HARBOR BROOK TREATMENT WETLANDS CSO STORAGE

CONTRACT NO. 1 - GENERAL

ONONDAGA COUNTY DEPARTMENT OF WATER ENVIRONMENT PROTECTION SYRACUSE, NEW YORK

RECORD DRAWINGS

GRIT CHAMBER PLAN

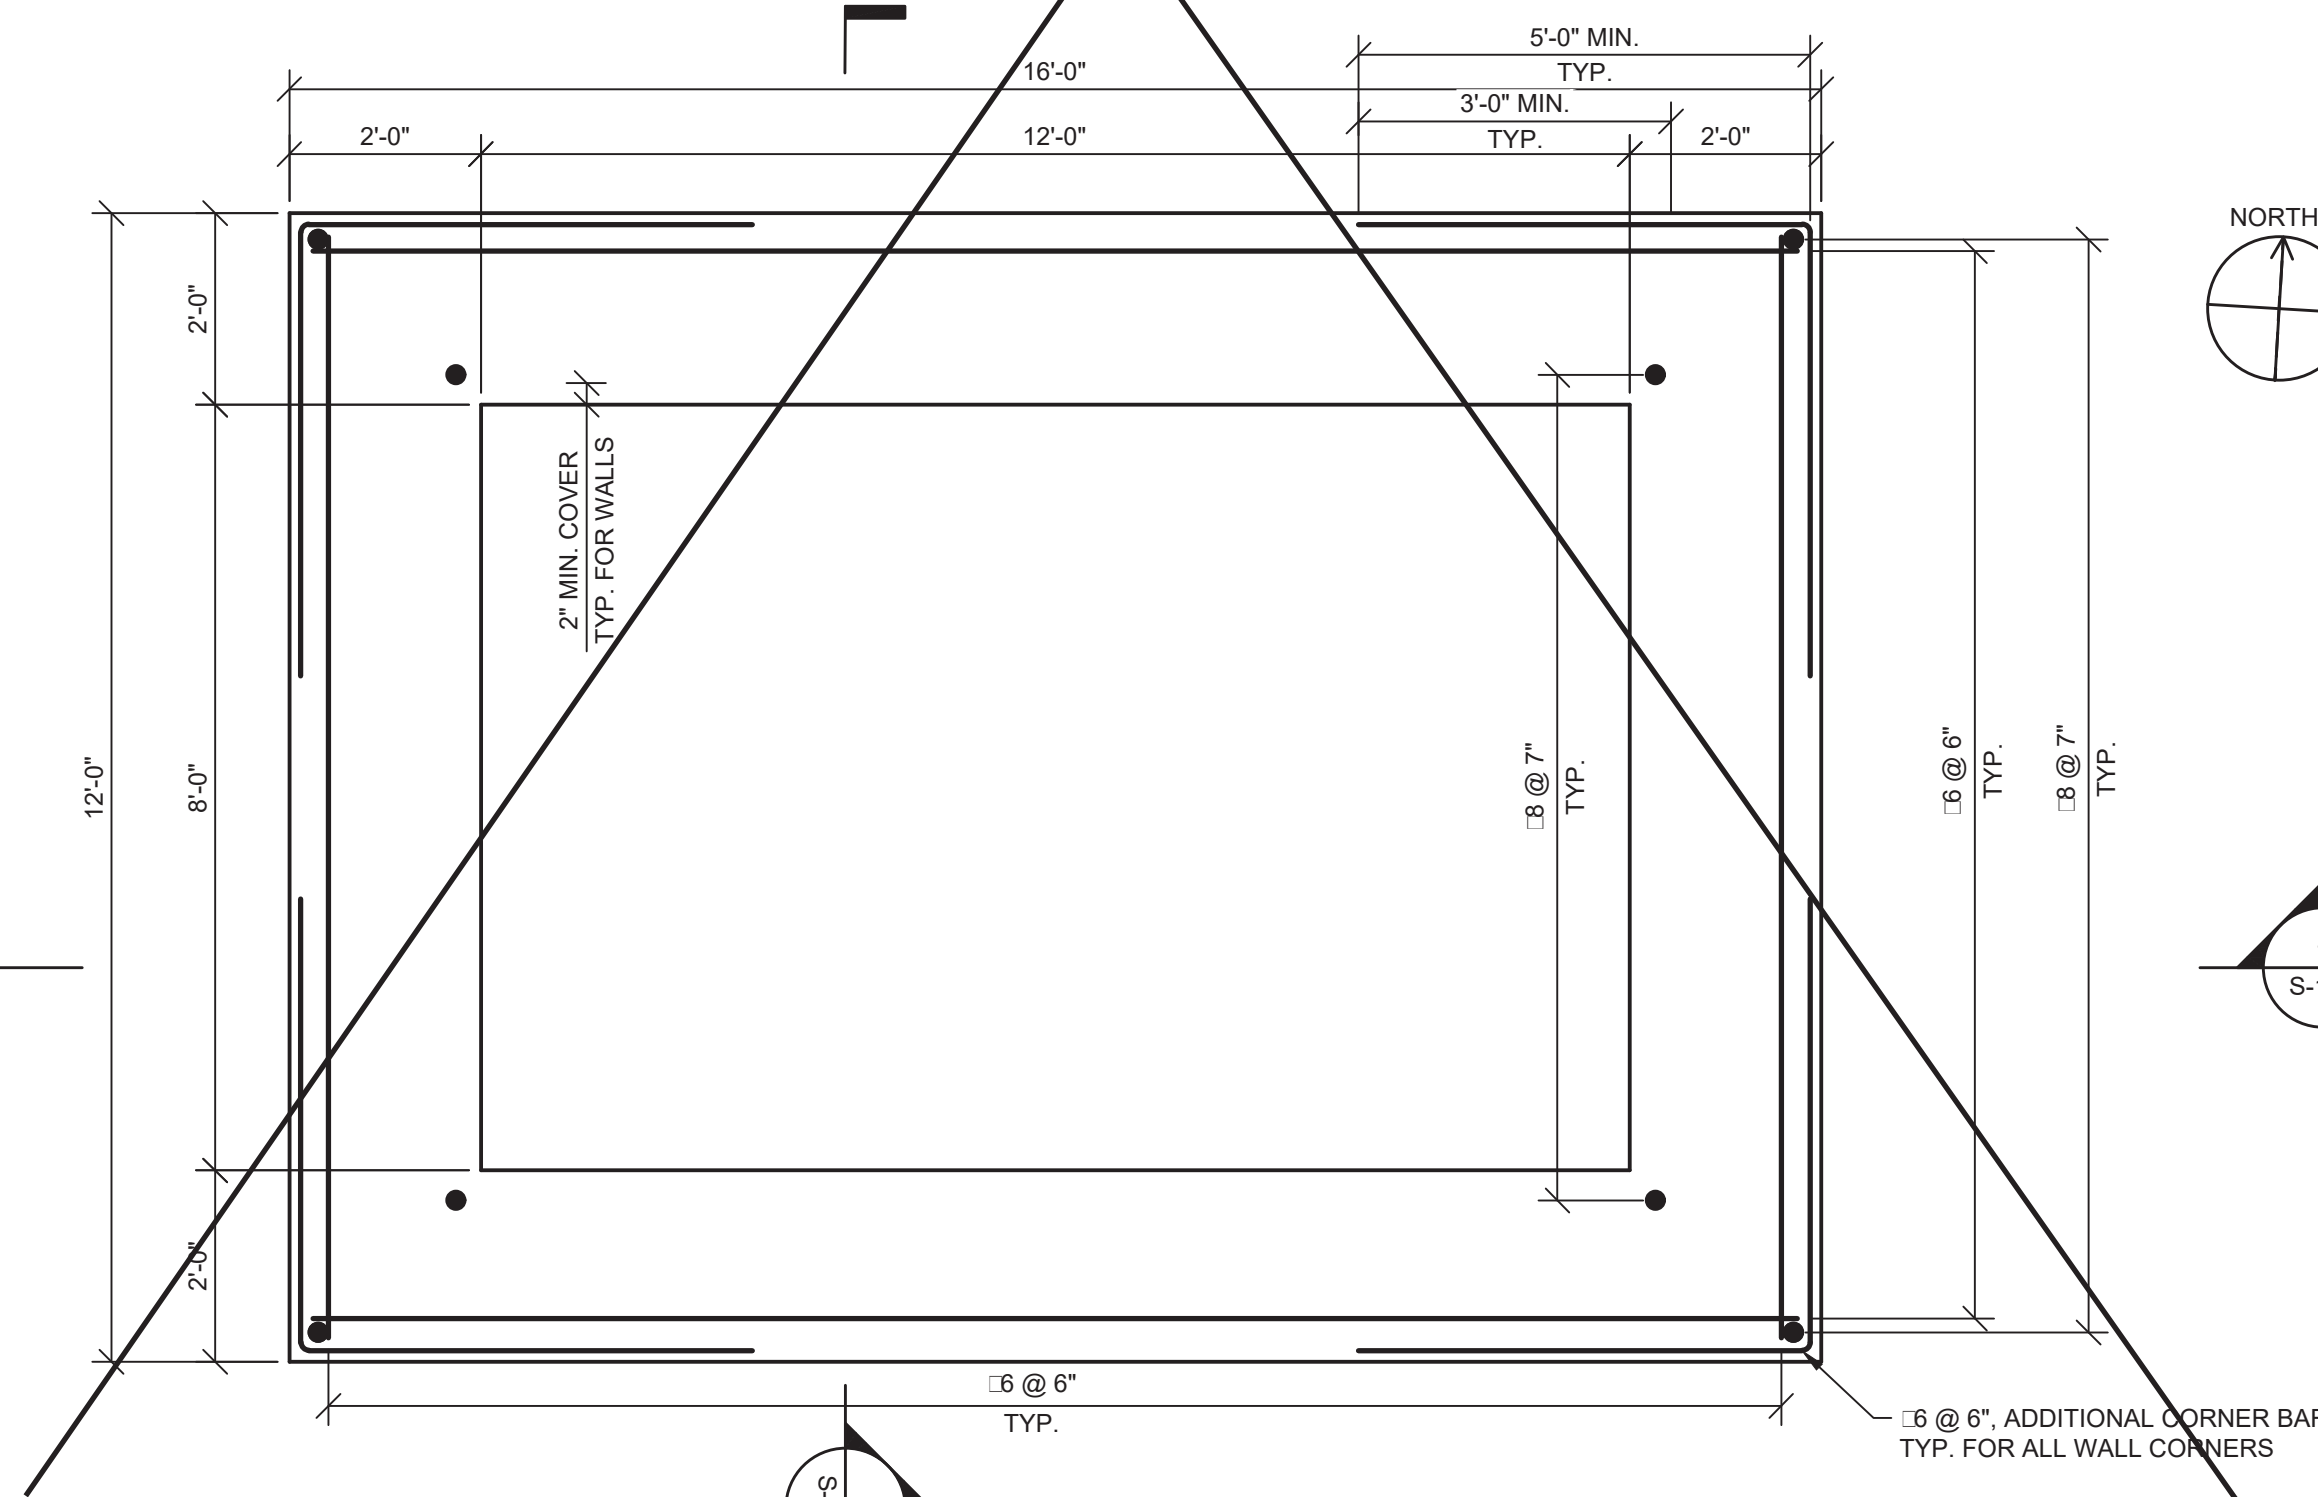
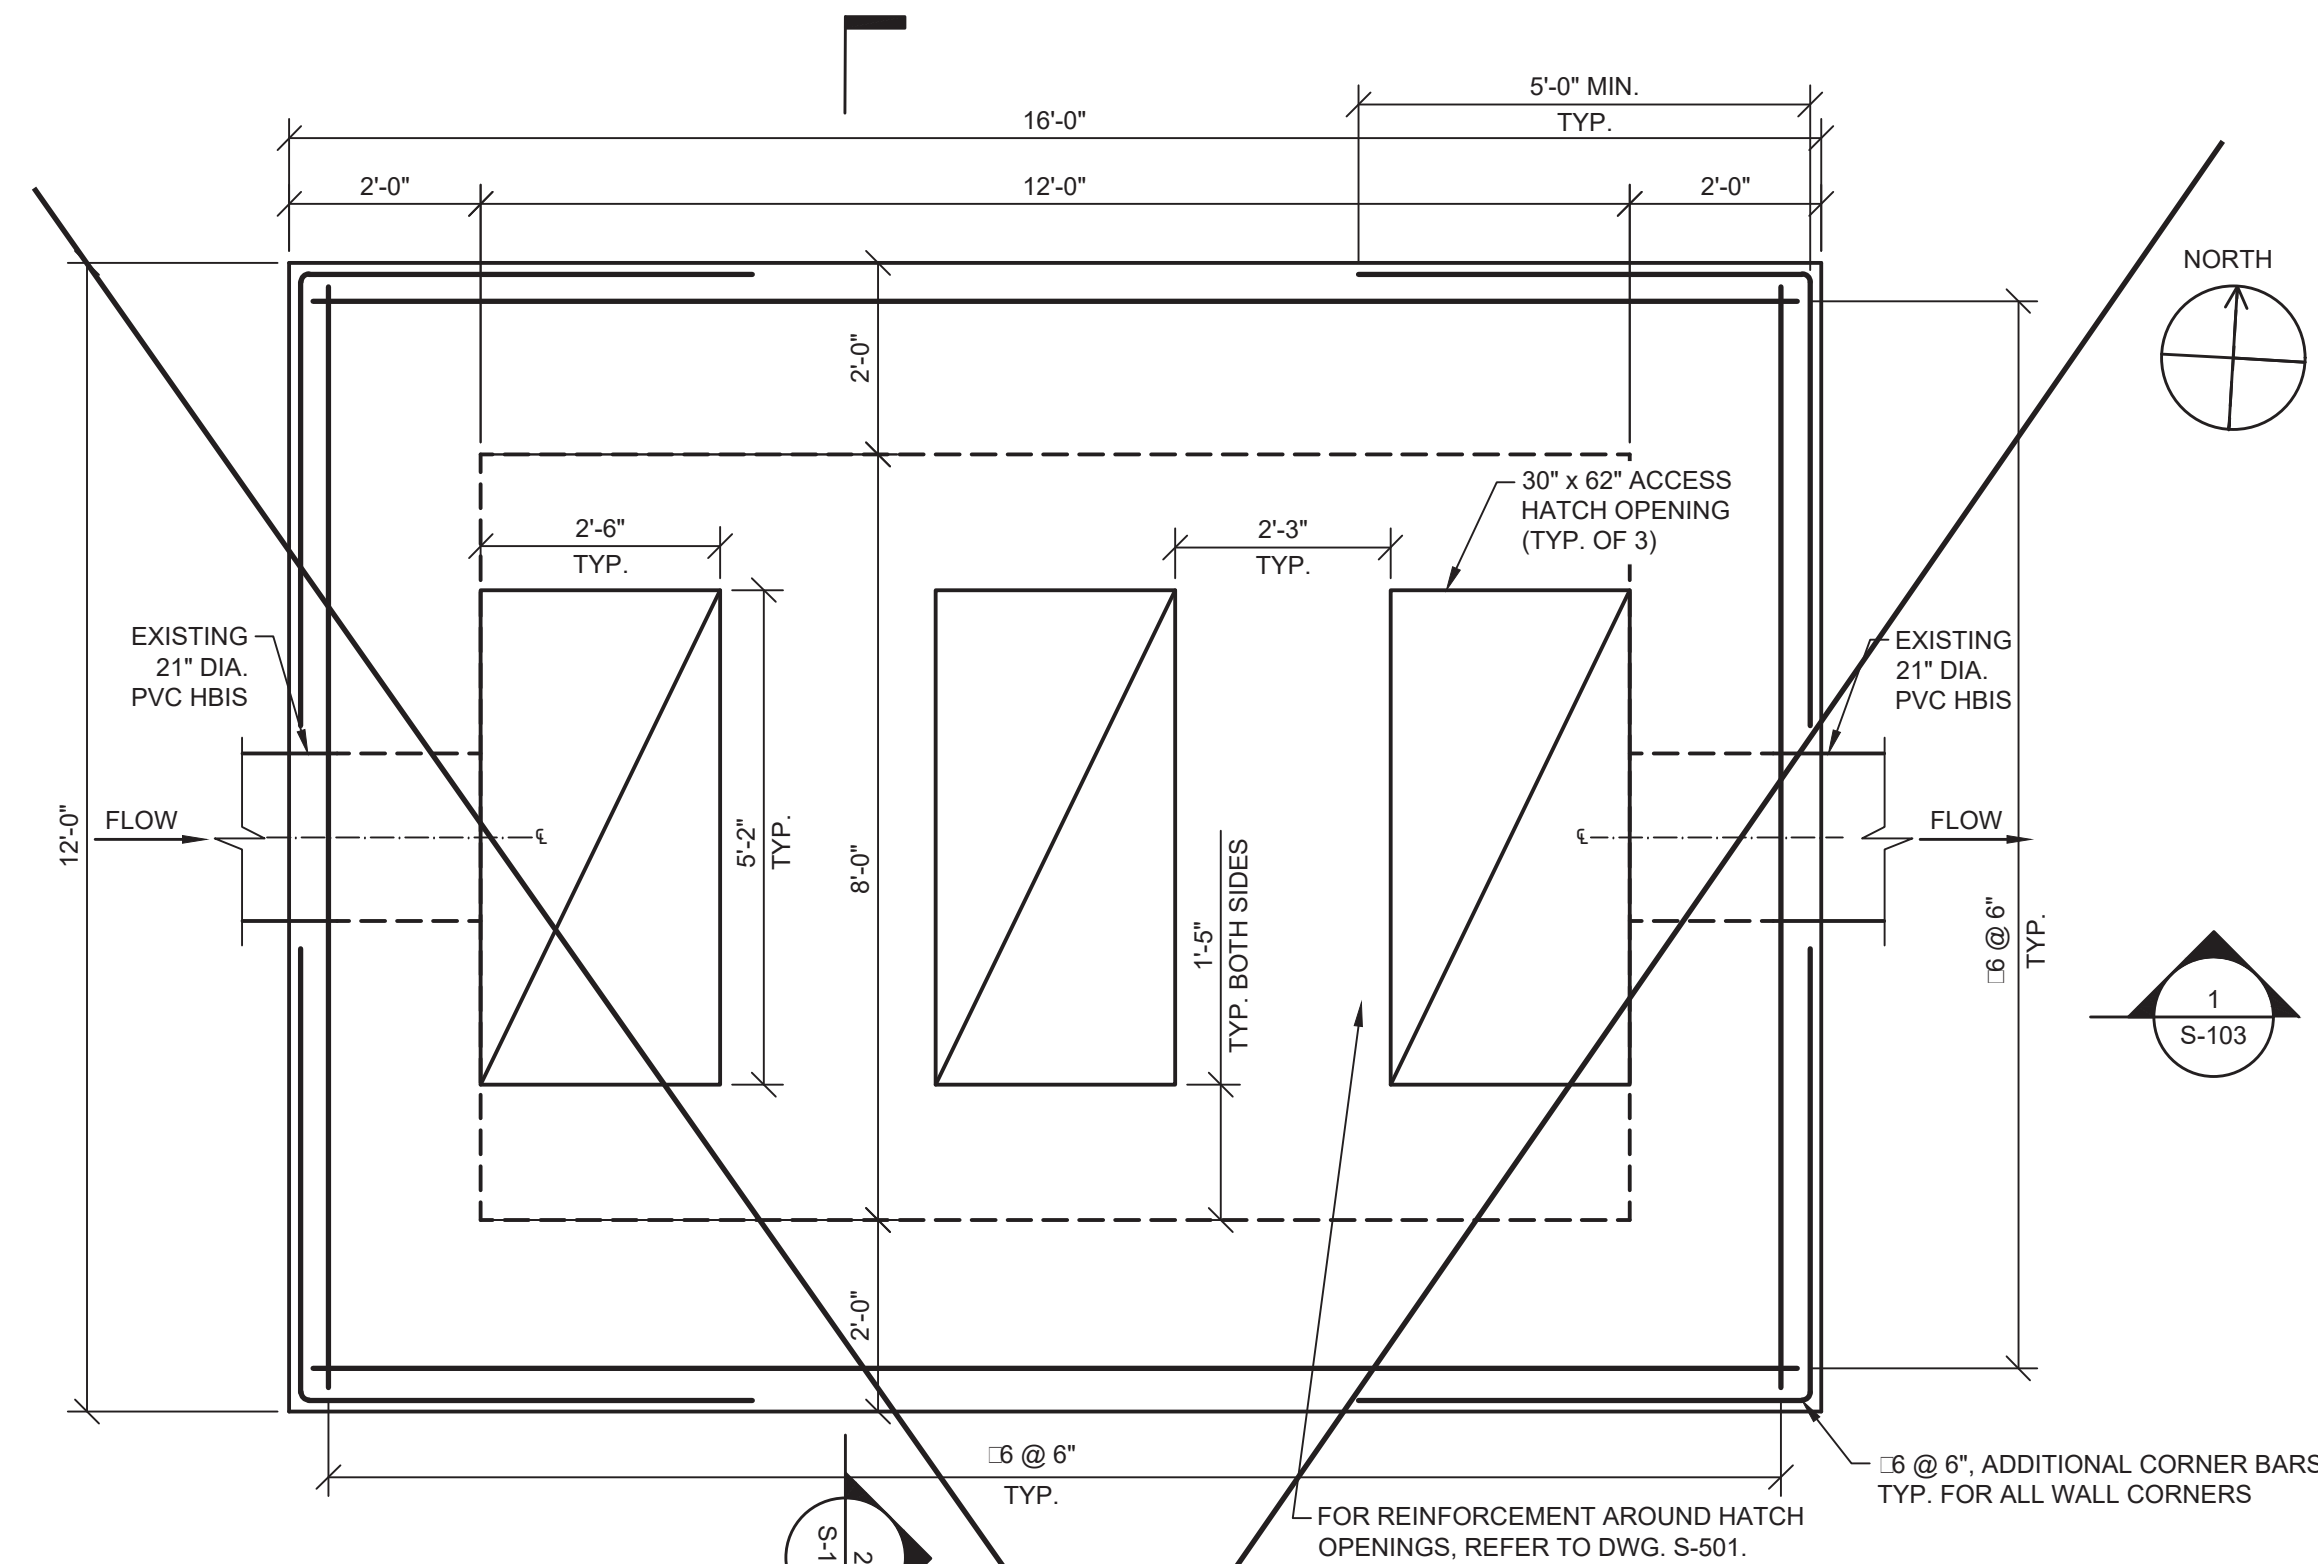
GRIT CHAMBER ELIMINATED BY MODIFICATION NO. 1, 6/10/2021
